IN THE MATTER OF LAHONTAN
REGIONAL WATER QUALITY CONTROL
BOARD RESOLUTION NO. R6V-2013-0060
CERTIFYING A FINAL ENVIRONMENTAL
IMPACT REPORT

CASE NO.
PETITION FOR REVIEW
REQUEST TO HOLD PETITION IN
ABEYANCE

**Attachment 1 –Main Comment Table
Hinkley Comprehensive Groundwater Cleanup Strategy
Draft Environmental Impact Report**

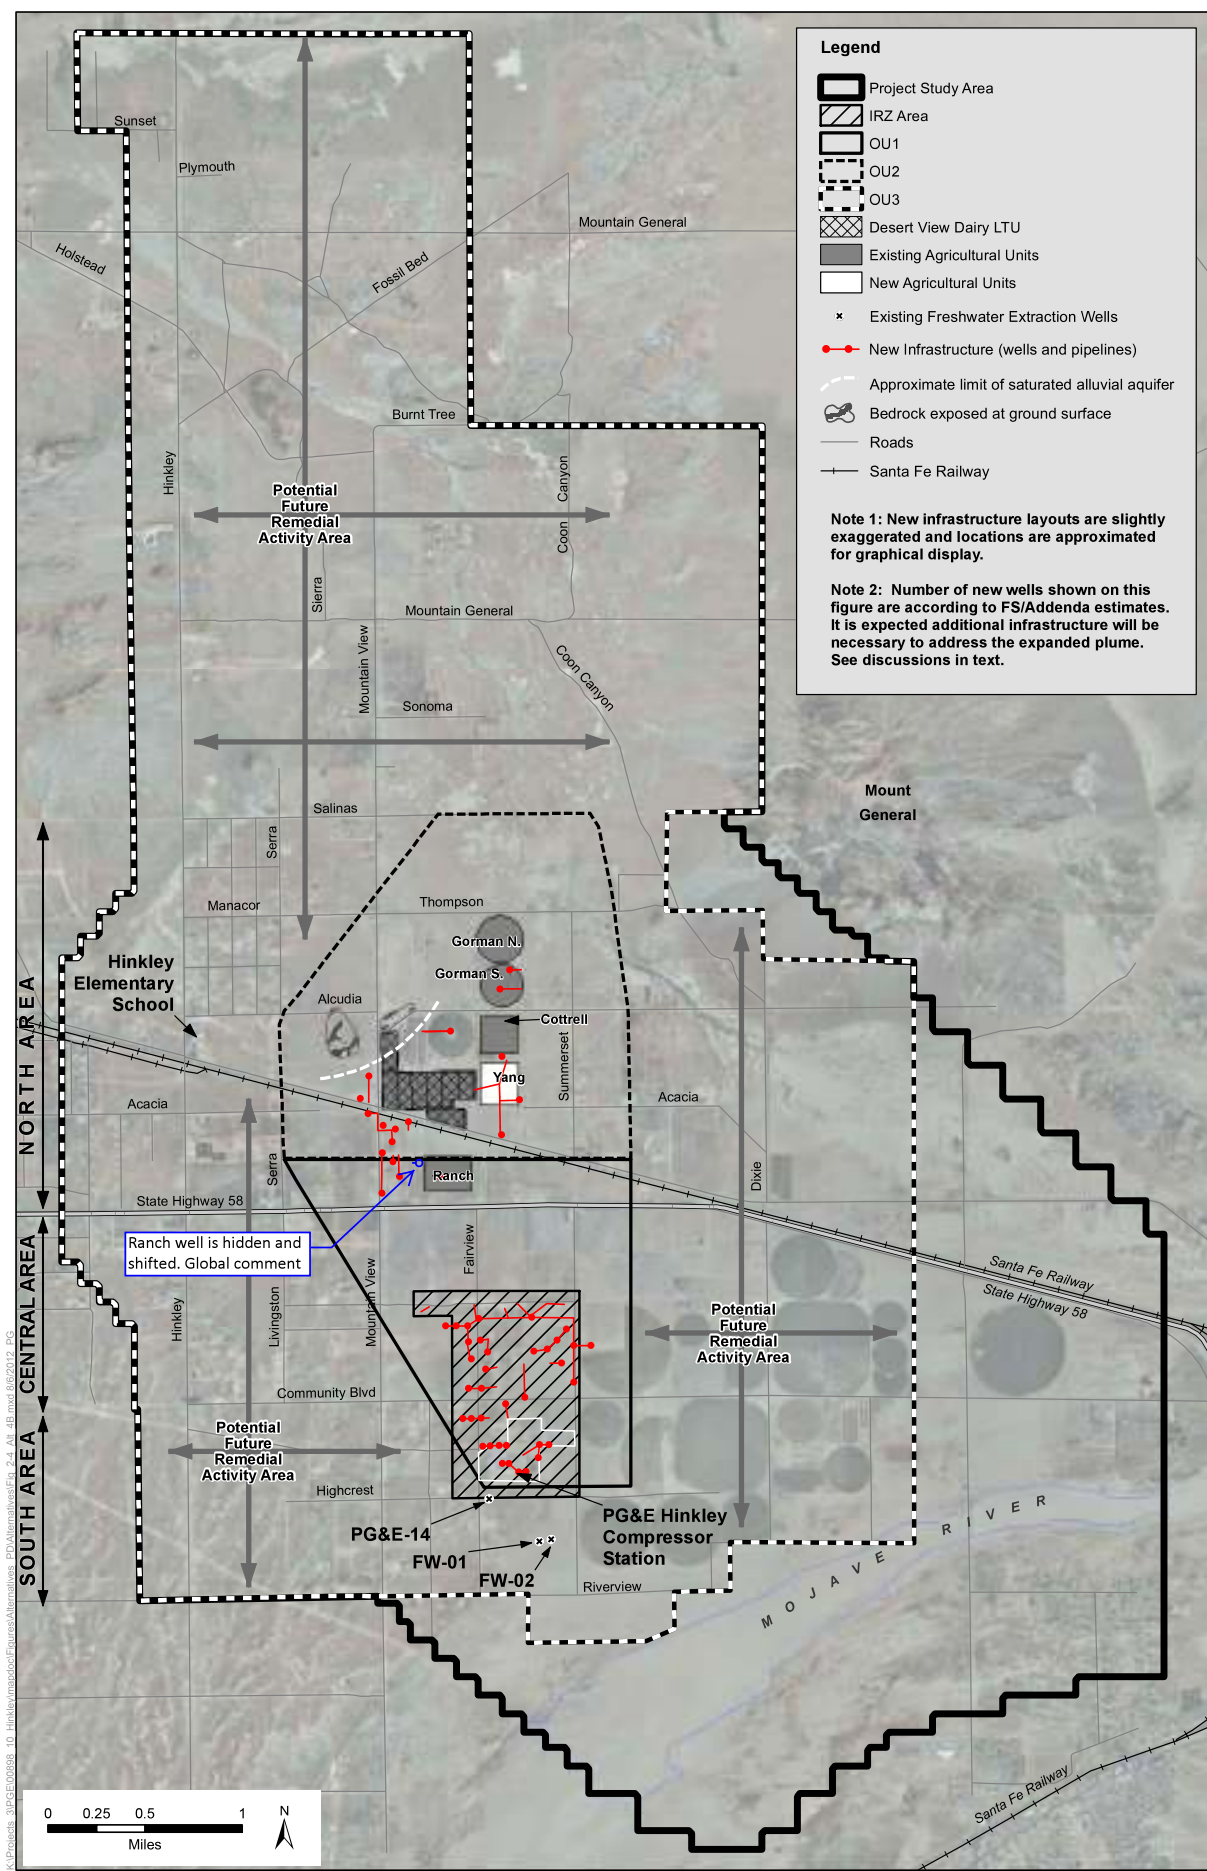
Comment [d1]: Totals are linear feet of trenching, we suggest adding a note to clarify

Comment [d4]: Suggest clarifying that well estimates include the number of wells to be constructed; not all wells may be operating at one time

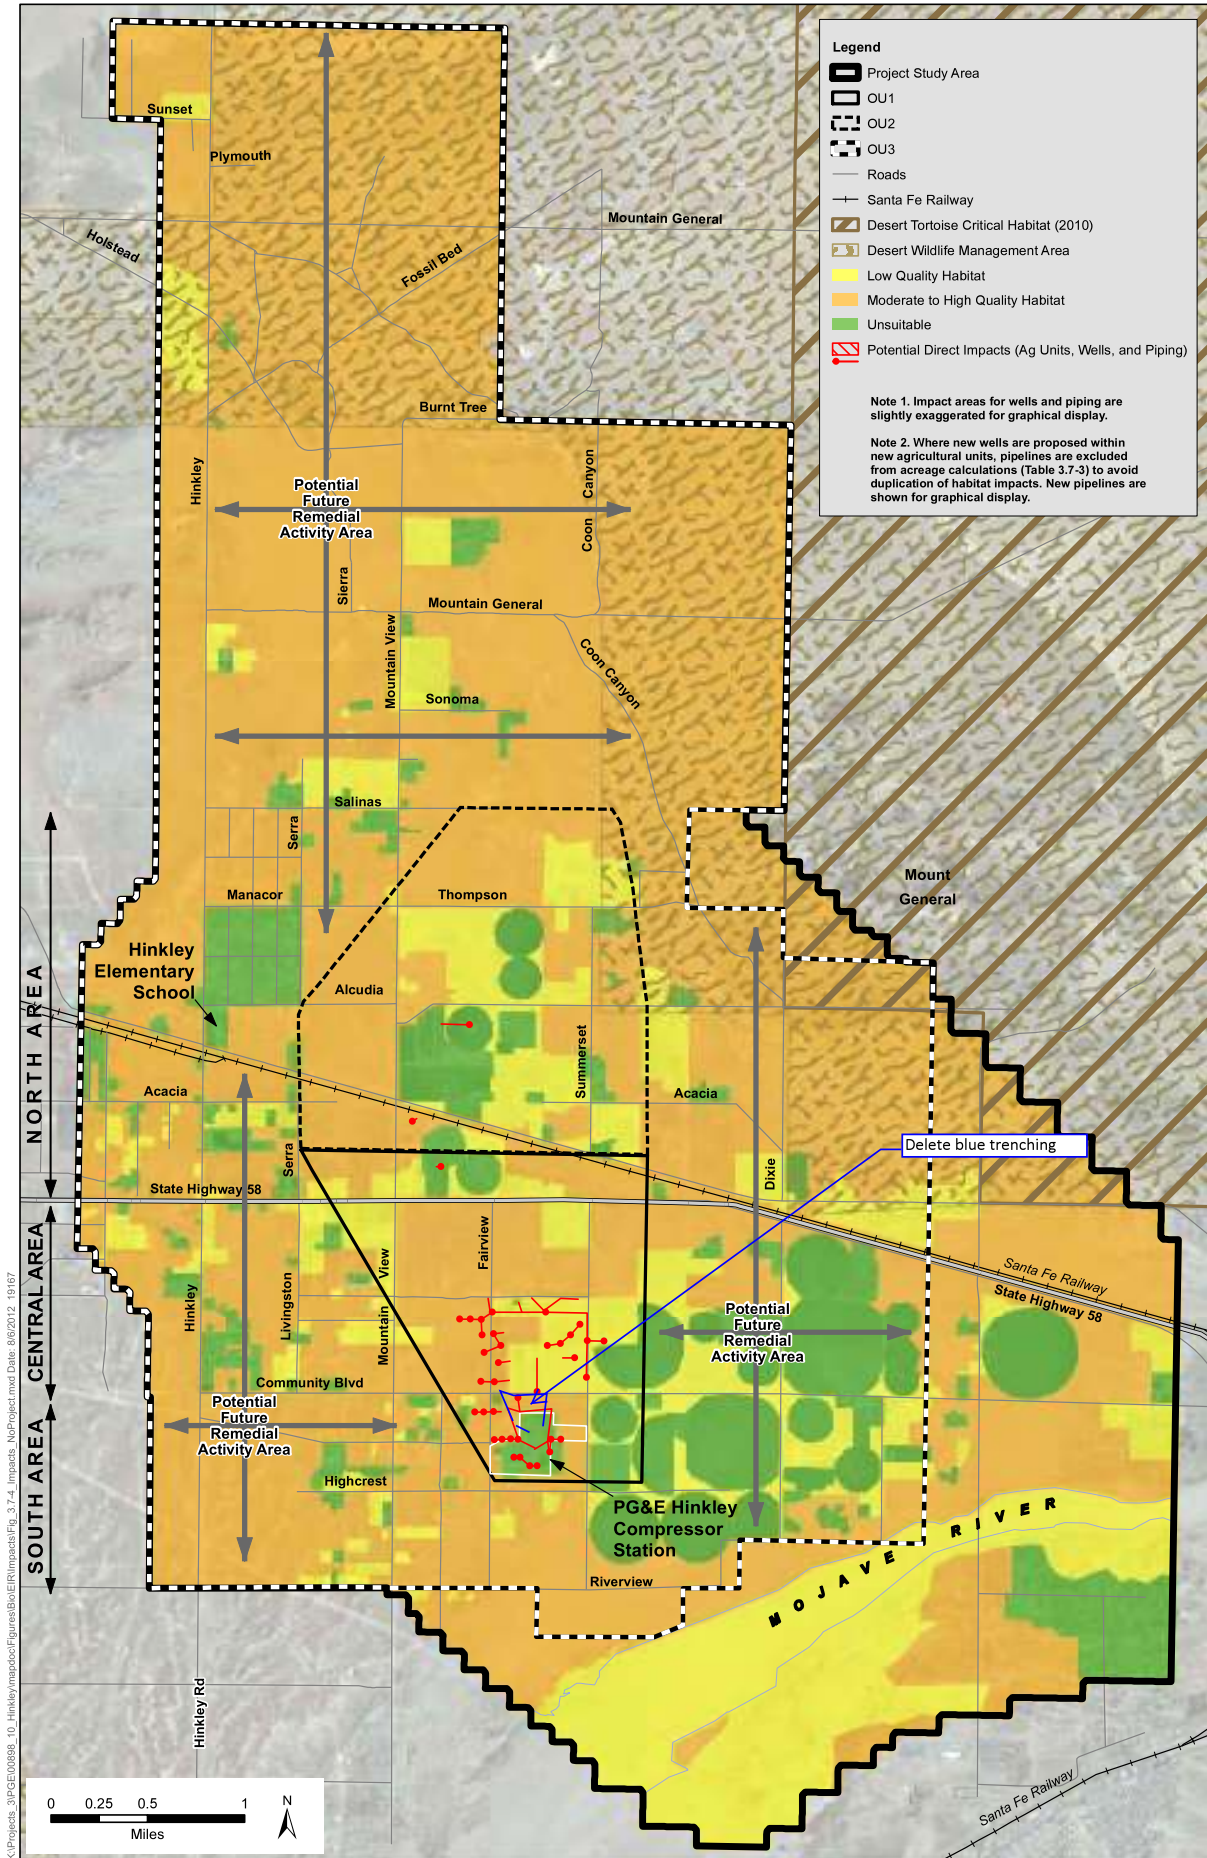
Comment [d11]: 240 VMT /month not daily

Comment [d12]: 424 VMT /month, not daily
